Prof. Liang Xiao  
Editor  
IEEE Transactions on Communications

Re: Decision on TCOM-TPS-21-0553 (IRS-Aided SWIPT: Joint Waveform,  
Active and Passive Beamforming Design Under Nonlinear Harvester Model)

Figure F1: Sorted equivalent subchannel amplitude with and without IRS versus  $N$  for  $M = 1$ ,  $L = 100$ ,  $\sigma_n^2 = -40$  dBm,  $B = 10$  MHz and  $d_H = d_V = 2$  m.

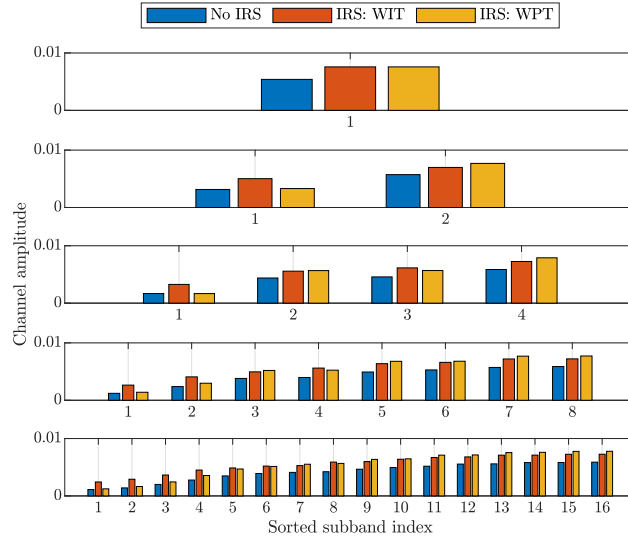
**Comment 2.2** — *The authors are suggested to study the impact of IRS passive beamforming on the waveform design without IRS. For example, they can show the optimized waveforms with versus without IRS to unveil the interplay between them. Or even better, analytically compare the two waveforms.*

**Comment 2.10** — *In Remark 2, the meaning of the sentence, “there exists a tradeoff for auxiliary link control in the frequency domain”, is not clear to me.*

**Response:** Thank you for the suggestion. To see this, we first show one realization of direct channel amplitude (without IRS) and composite channel amplitude (with IRS) for WIT and WPT in Fig. F1. It is observed that under the configuration of choice, the WPT-optimized passive beamforming tends to concentrate the channel energy to relatively strong subbands, while the WIT-optimized passive beamforming achieves some balance among all subbands (similar to water-filling at high SNR).

Fig. 6 reveals how IRS influences the (sorted) equivalent subchannel amplitude for one channel realization. Due to the flexible subchannel design enabled by passive beamforming, the optimal amplitude distribution for WIT and WPT are dissimilar. Under the specified configuration, the WPT-optimized IRS aligns the strong subbands to exploit the rectifier nonlinearity. On the other hand, the WIT-optimized IRS provides a fair gain over all subchannels when  $L$  is sufficiently large. This is reminiscent of the WF scheme at high SNR, but is realized by channel alignment instead of resource allocation. Nevertheless, the amplitude of modulated and multisine waveforms remains approximately unchanged when adding an IRS (the plots are not attached). In other words, IRS has a subtle impact on the waveform design.

**Response:** By ‘auxiliary link control in the frequency domain’, we intended to emphasize that the auxiliary link cannot be designed independently at different frequencies, and subchannel design flexibility arises in the presence of IRS. The composite channel can be tuned adaptively to satisfy the specific requirement of the multi-carrier transmission. For example, one can design the reflection pattern to either enhance the strongest subband (e.g.,  $\max_{\phi, n} \|\mathbf{h}_n\|$ ), or improve fairness among subbands (e.g.,  $\max_{\phi} \min_n \|\mathbf{h}_n\|$ ). We have added Fig. F1 and updated the Remark 2 to clarify this point.

The cascaded channel varies at different subbands, but the reflection cannot be designed independently at different frequencies. Therefore, there exists a tradeoff for the passive beamforming design in the frequency domain, and the composite subchannels should be tuned adaptively to meet the specific requirement of multi-carrier SWIPT. For example, one can design the reflection pattern to either enhance the strongest subband (e.g.,  $\max_{\phi, n} \|\mathbf{h}_n\|$ ), or improve the fairness among subbands (e.g.,  $\max_{\phi} \min_n \|\mathbf{h}_n\|$ ). That is to say, IRS essentially enables a flexible subchannel design. In the MISO case, a similar effect also exists in the spatial domain. Therefore, each reflection coefficient is indeed shared by  $M$  antennas over  $N$  subbands.
